| Request | - | Major Site Plan Review for a new industrial building and parking lot |
| Location | - | 6123 Jason Street (1800 Nathan Street) |

MAJOR SITE PLAN REVIEW
TOLEDO CITY PLAN COMMISSION
REF: SPR-50-23
DATE: February 8, 2024
TIME: 2:00 P.M.

LANDSCAPE PLAN

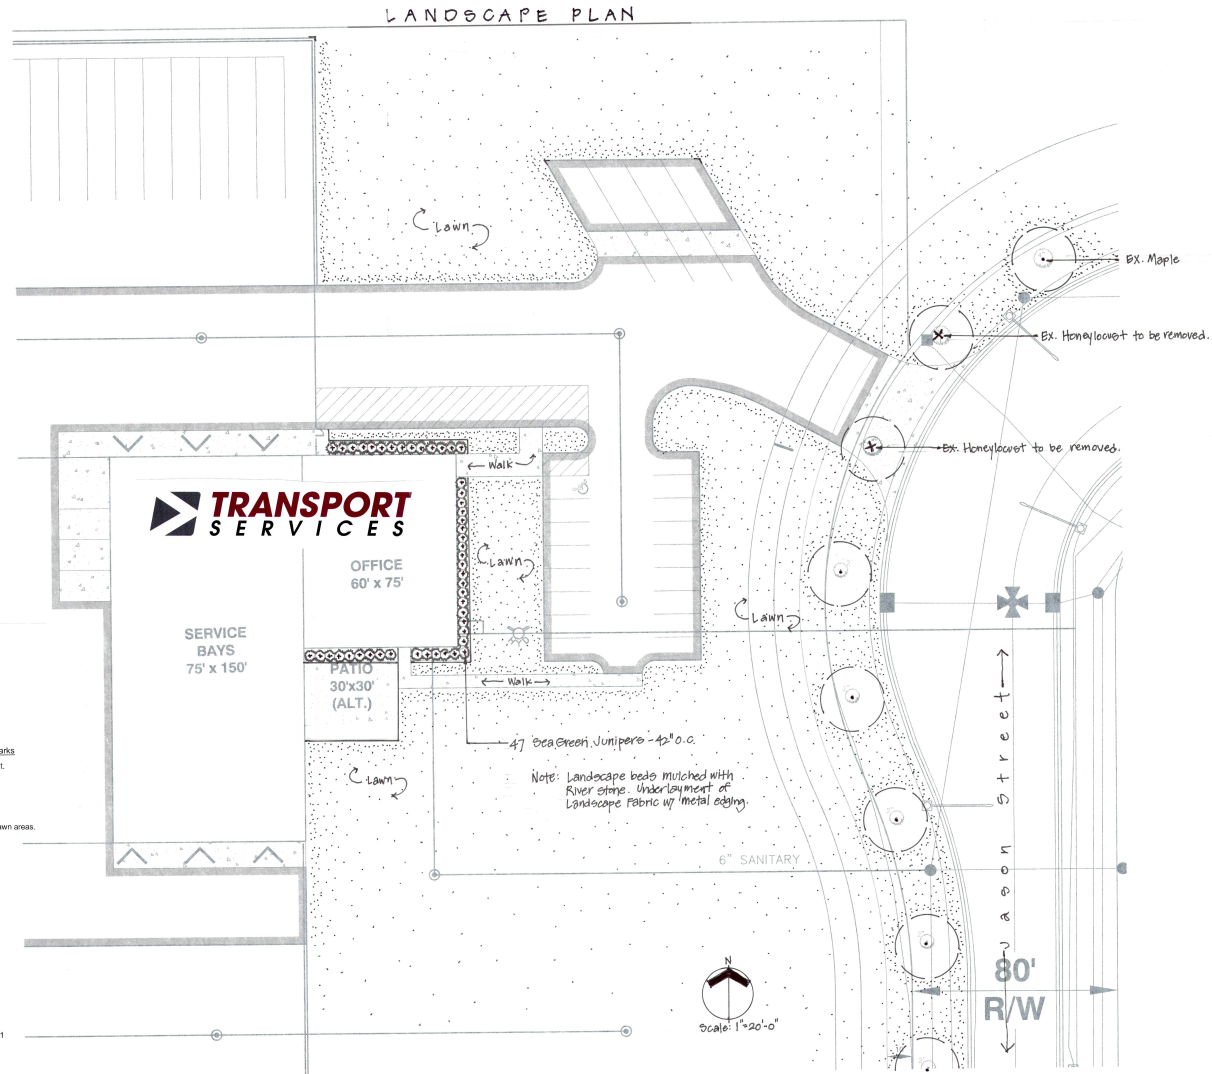
- a. Per TMC§1108.0202 a 30-foot-wide frontage greenbelt is required along Jason Street and Nathan Street and shall include one tree for every 30 feet of frontage. Eighteen (18) trees are required along Jason Street and 24 trees are required along Nathan Street. There is no landscape buffer depicted on the landscape plan or any required trees along Jason or Nathan Street. **Not acceptable as depicted. A 30 foot frontage greenbelt shall be installed along Jason Street and Nathan Street with 18 and 24 trees respectively.**

- b. Per TMC§1108.0202 a solid evergreen hedge is required along Jason Street and Nathan Street because parking is proposed to be developed in the front of the property. The landscape plan does not depict the required evergreen planting hedge. In the case of the parking area along Nathan Street, an 8 foot high chain link fence is depicted on the site plan. **Not acceptable as depicted. A solid evergreen hedge for the parking lot along Jason Street and a solid evergreen hedge or privacy fence for the parking area along Nathan Street shall be installed.**

- d. Per TMC§1108.0203(G) dumpsters are required to be screened on all sides with any combination of evergreen plantings, fence, or wall that is a minimum in height of six feet. Screening is not depicted on the landscape plan. **Not acceptable as depicted. The dumpster shall be screened in accordance with TMC§1108.0203.**

- f. Per TMC§1108.0204(B) the total interior landscaping required for the customer/employee parking lot shall include 340 square feet of interior landscaping containing four (4) canopy trees and 11 shrubs. The landscape plan does not depict any parking lot landscaping. **Not acceptable as depicted. Four (4) canopy trees and 11 shrubs shall be provided to meet this requirement.**

NORTH AND EAST BUILDING ELEVATIONS

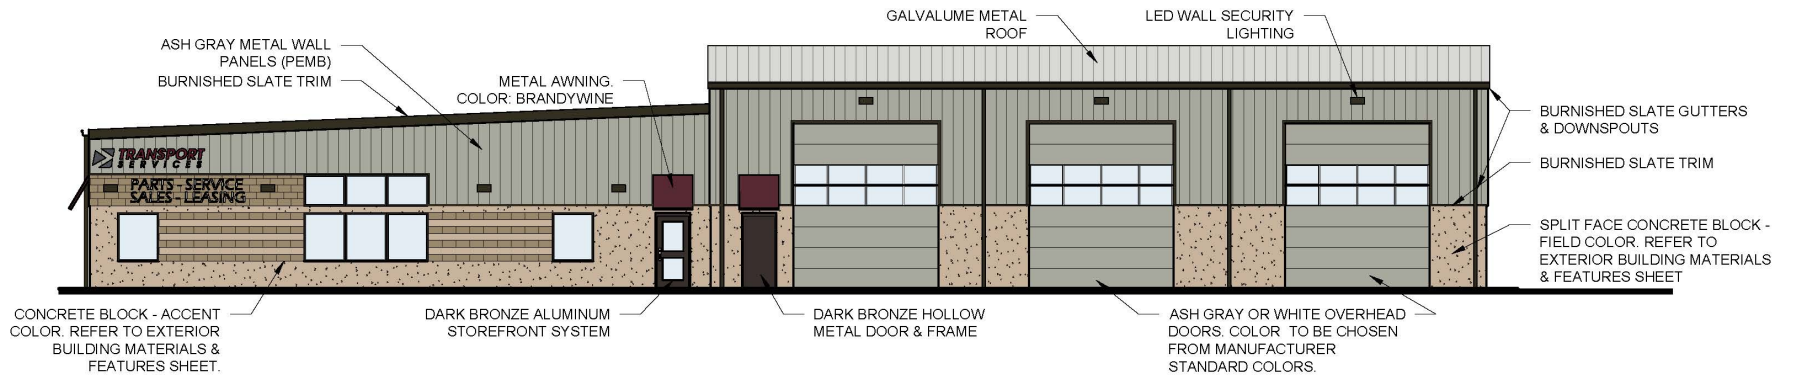
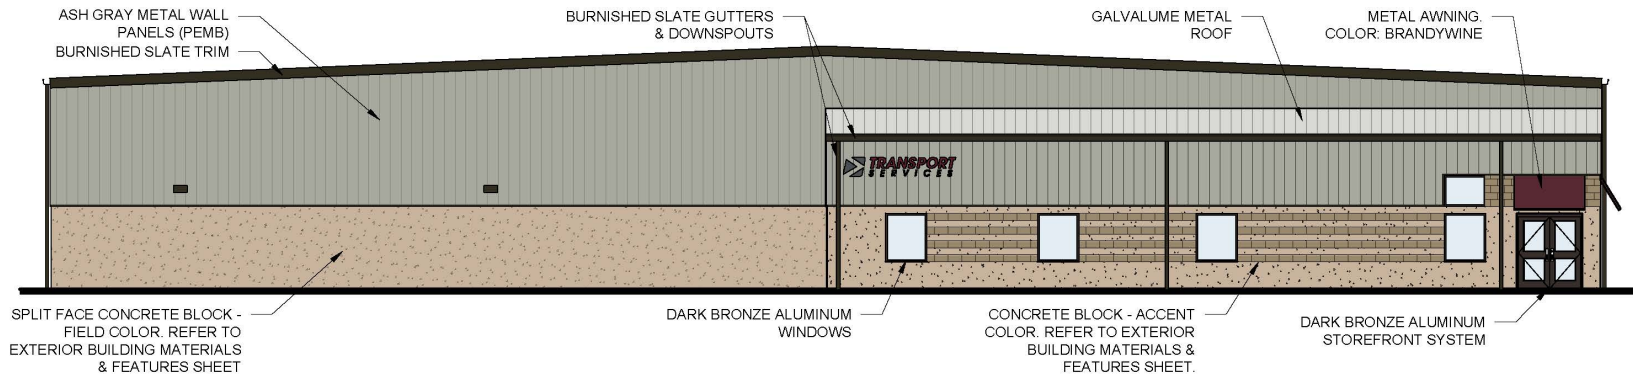
39. Per TMC§1109.0400 along major streets, at least 30 percent of the building frontage shall not consist of a blank wall. The building facade shall be low-reflectance, subtle, neutral or earth tone colors with the exception of trim and accent areas. In addition, all structures shall utilize durable building materials such as brick, stone, metal, or concrete. **Acceptable as depicted.**
